IDAP REPORT

Property:	48 Rickard Road STRATHFIELD Lot: 15 DP: 16967 DA2022.106
Proposal:	Demolition of existing structures, construction of two storey dwelling along with detached outbuilding, in-ground pool & front boundary fence.
Applicant:	K Murad
Owner:	A Zakir & Z Hussain
Date of lodgement:	6 June 2022
Notification period:	17 June 2022 - 1 July 2022
Submissions received:	1 submission received
Assessment officer:	L Gibson
Estimated cost of works:	\$979,000.00
Zoning:	R2-Low Density Residential - SLEP 2012
Heritage:	No
Flood affected:	No
Is a Clause 4.6 Variation Proposed:	N/A
RECOMMENDATION OF OFFICER:	APPROVAL

Figure 12: Current proposal of dwelling façade

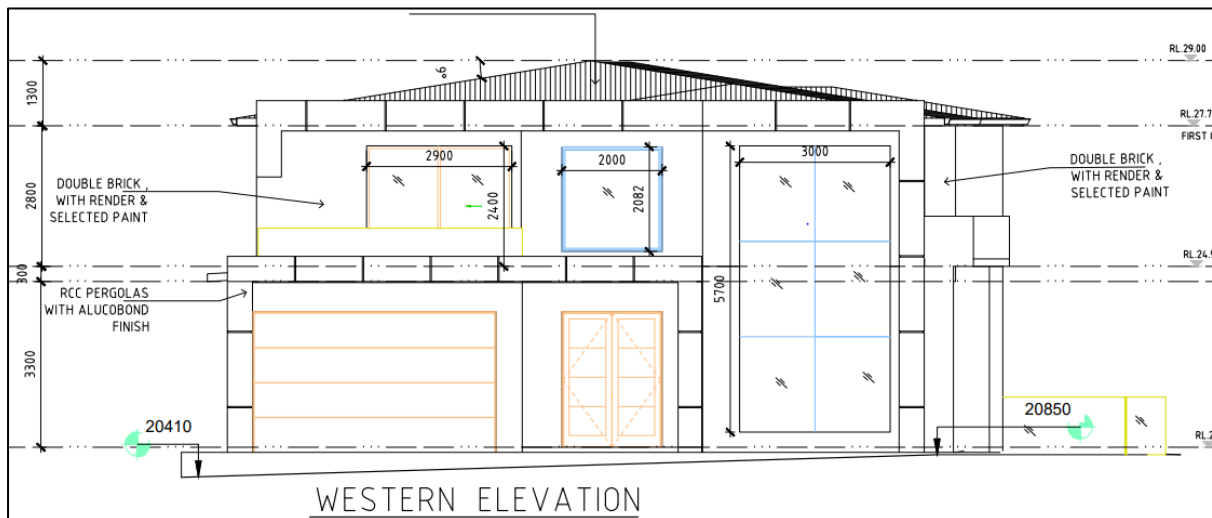
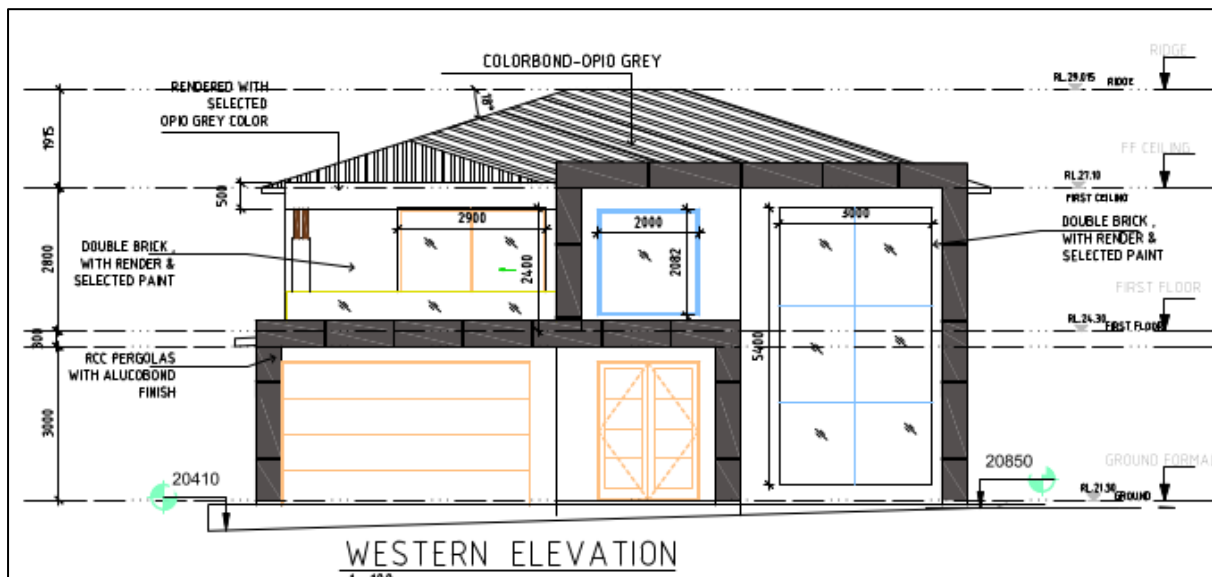
The proposal seeks to construct a new two storey dwelling with pitched roof form, rendered exterior walls and alucobond cladded accent blade walls to the façade. As previously mentioned, existing development in the street features an array of architectural styles. There is a growing emergence of new 2 storey dwelling development of brick and render exterior finishes however all are comprised of pitched tiled roof forms.

The design has been revised throughout the assessment process to achieve a more compatible built form with the streetscape (refer to Figures 11 and 12 below for comparison of dwelling's façade). The revised scheme has sought a breakup of the alucobond clad parapet which now extends across only half the façade. The revised design now achieves compliant side setbacks and whilst some elements of the design encroach upon the prevailing 9m front setback, these elements are contained to the front porch and ground floor open pergola structure to the garage. These elements do not provide any considerable bulk and scale and thus is acceptable in this instance.

The increased front and side setbacks along with the various façade changes has assisted in reducing the bulk and scale of the development as well as allowing for the pitched roof line to be more readily visible in the street. The revised design is more commensurate with existing development in the streetscape and acceptable in this regard.

Figure 13: 9AM shadow diagrams (Winter Solstice)

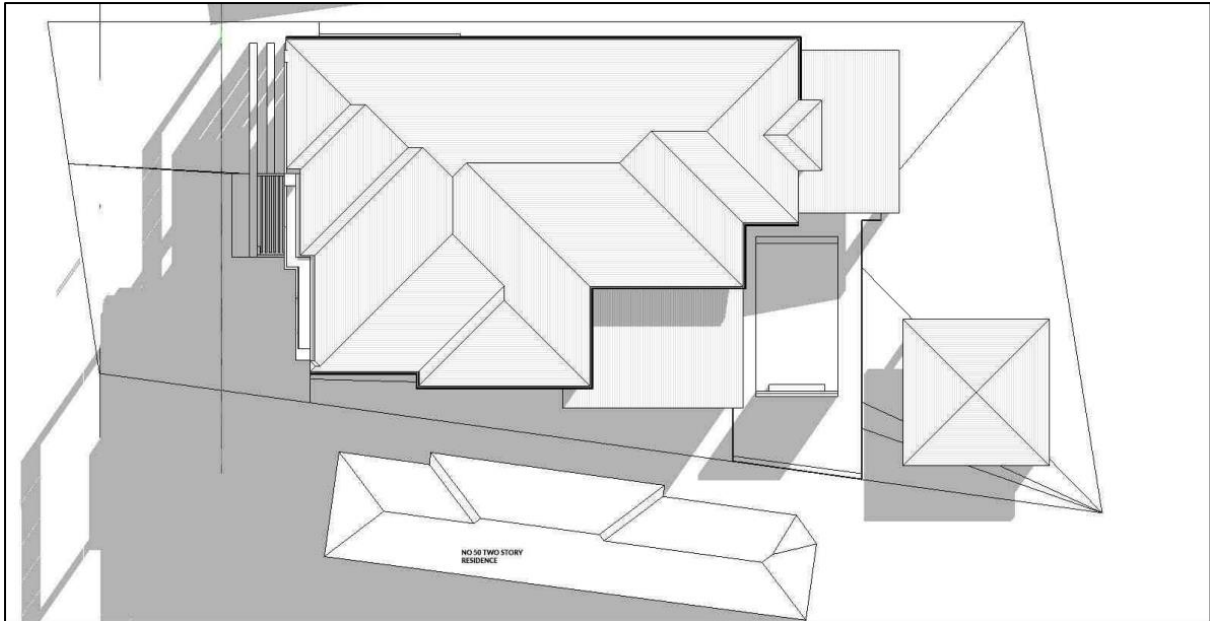
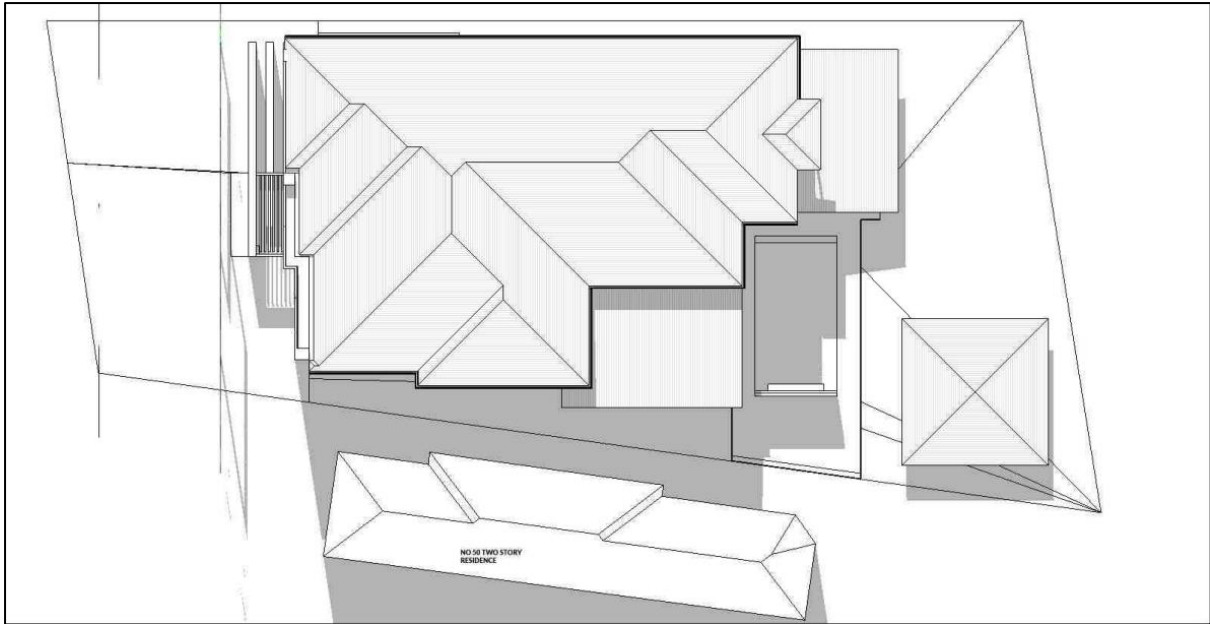
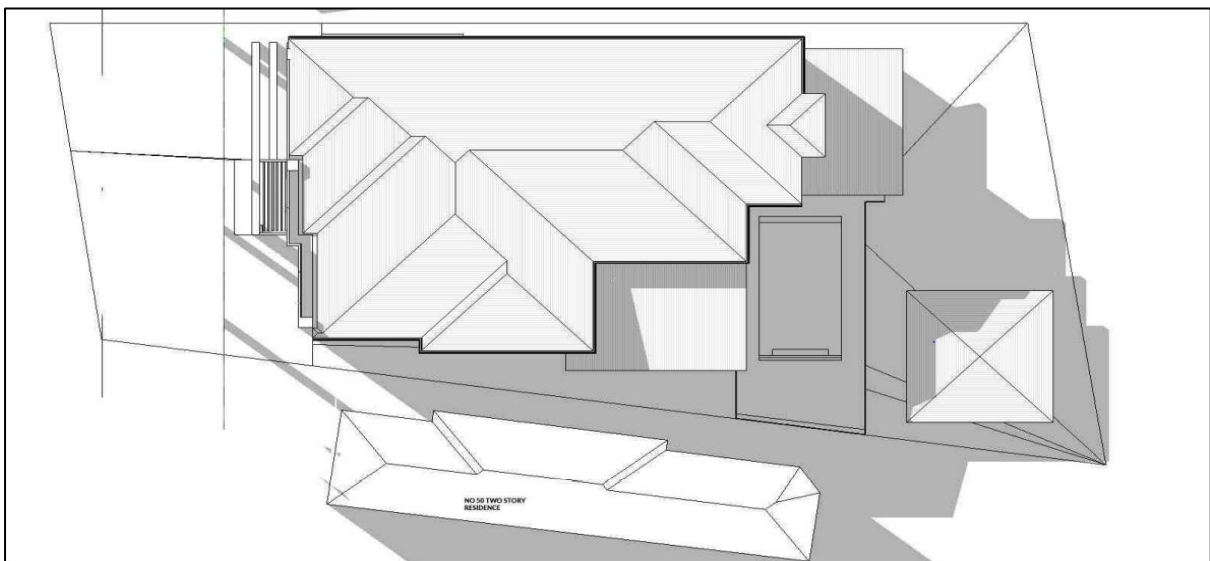
The dwelling provides an east-west orientation resulting in an unavoidable degree of overshadowing to the south. Accordingly, the proposal is unable to achieve 3 hours direct solar access to adjoining dwellings as required by Section 6.2 of Part A of the SCDCP 2005.

The southern adjoining dwelling at 50 Rickard Road is provided with a number of north-facing windows to its northern side elevation. The proposed development would inevitably result in additional shadows cast over the southern adjoining neighbour including to these northerly windows.

During the assessment process, Council's Assessing Officer provided the Applicant with the opportunity to demonstrate that the proposed void would not result in any further loss of solar access to the southern adjoining resident. The Figures below are excerpts from the revised shadow diagrams and additional shadow on elevation plans submitted during the assessment process. Note the void space has been lowered in height with separate roof line from the remainder of the dwelling.

Whilst amended documentation was prepared and submitted to Council, the additional modelling still shows that the proposal would result in overshadowing to the southern adjoining resident throughout most of the day. Whilst the proposed void has been lowered from 6.8m to 5.9m during the assessment process, it is still evident that the void would cast an additional shadow over the southern adjoining property resulting in further loss of solar access through the day particularly in the afternoon hours.

Accordingly, the void is not supported and it is therefore recommended that the void be deleted with a floor to ceiling height of 3m provided to the living room of the dwelling.
